# HISTORIC AND DESIGN REVIEW COMMISSION

**HDRC CASE NO:** 2021-410  
**ADDRESS:** 126 POTOMAC ST  
**LEGAL DESCRIPTION:** NCB 585 BLK 3 LOT 7 & 8  
**ZONING:** RM-4, H  
**CITY COUNCIL DIST.:** 2  
**DISTRICT:** Dignowity Hill Historic District  
**APPLICANT:** Felix Ziga/Ziga Architecture Studio PLLC  
**OWNER:** Brett Henneke  
**TYPE OF WORK:** Construction of a 2-story residential structure with a detached accessory structure  
**APPLICATION RECEIVED:** August 13, 2021  
**60-DAY REVIEW:** Not applicable due to City Council Emergency Orders  
**CASE MANAGER:** Edward Hall

**Historic and Design Review Commission**  
***Design Review Committee Report***

## **HENNEKE RESIDENCE – 126 POTOMAC – NARRATIVE**

#### **Design Review Committee – 8/24/21 - Comments and Suggestions and design adjustments**

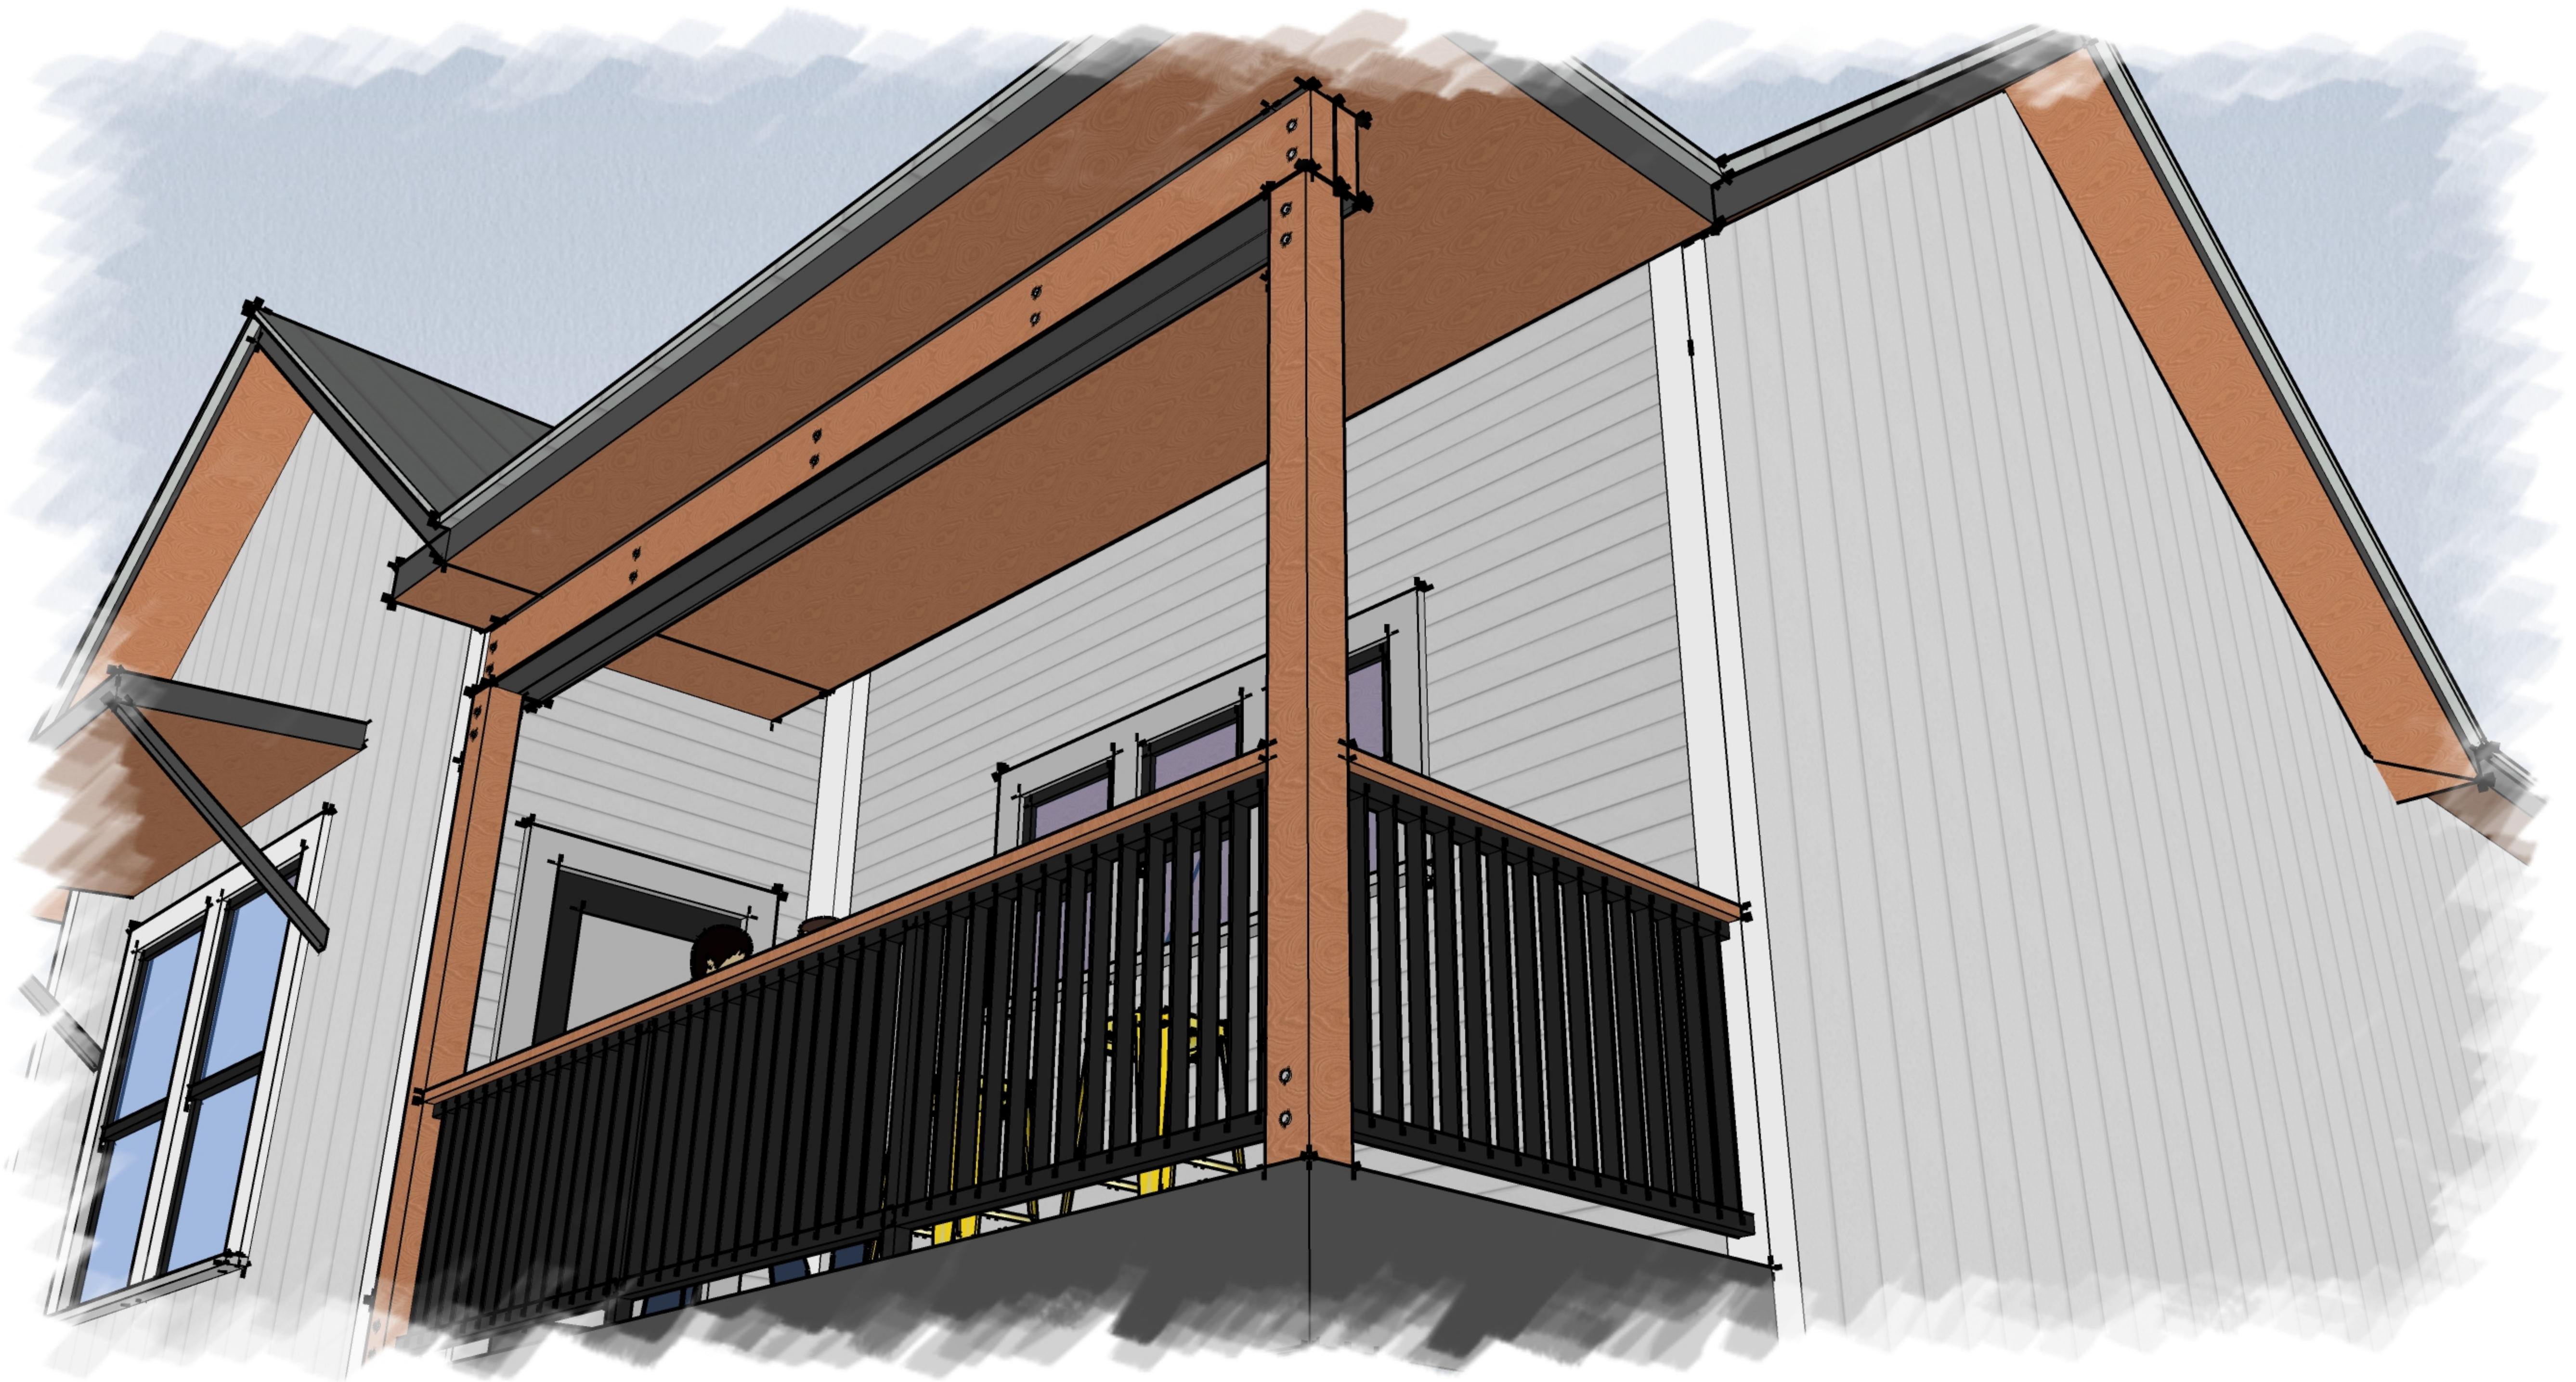
MS: Comments on the site plan. Single-family development on this lot is most appropriate.

MS: Questions regarding attached parking. FZ: Driven by the client's desire.

MS: If garage is separated from house, it would create more space on site due to minimum setback of only five feet at the rear.

CF: May be difficult to find large support for the attached garage from the Commission.

CF: Questions about setbacks.

CF: Pay close attention to the setbacks on Potomac. It would be most appropriate to have a greater setback than the historic setbacks on Potomac (at least equal to).

Upon feedback from the Design Review Committee meeting, we have detached the initially proposed attached garage. The garage has is also now being proposed as a 2-car carport. The detached accessory structure has allowed the rear setback to be decreased from minimum 10' to minimum 5', thus allowing the main structure to be setback further to comply with staff recommended front setback requirements.

The intent is to have the architectural detail language from the main house, carry over into the accessory structure. Sealed wood columns, with contemporary steel plate bracket connections, will connect to I-beam flitch beam in order to span the 20 ft by 20 ft unencumbered by intermediary columns. The proposed wood framing will be sealed pre-manufactured wood trusses, capped by a standing seam metal roof to match the main structure.
